64<sup>th</sup> WP2 Meeting – 29/03/2016

# Outcome of the Powering Review

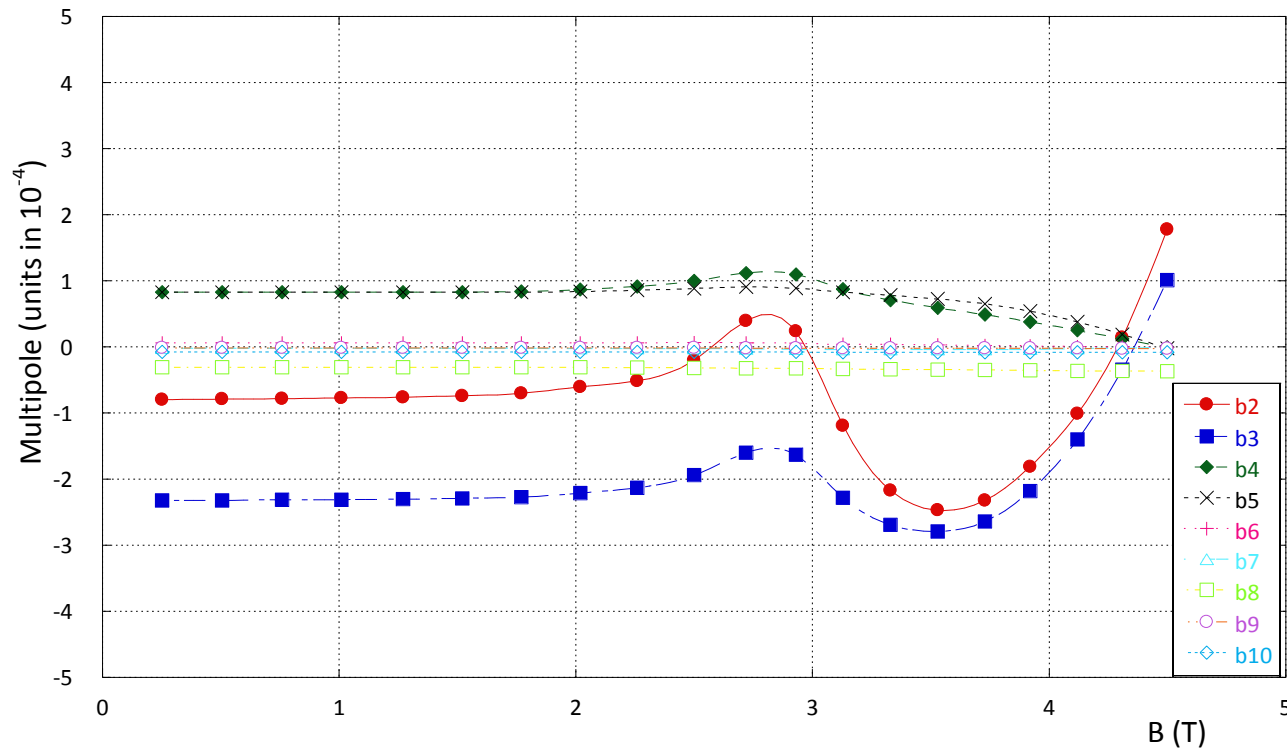
- ITs powering: move to the proposed powering scheme → implies two quadrant power converter
- D1-D2 powering: keep present baseline
- Implication of 11 T trim on Magnet Protection should be further analysed
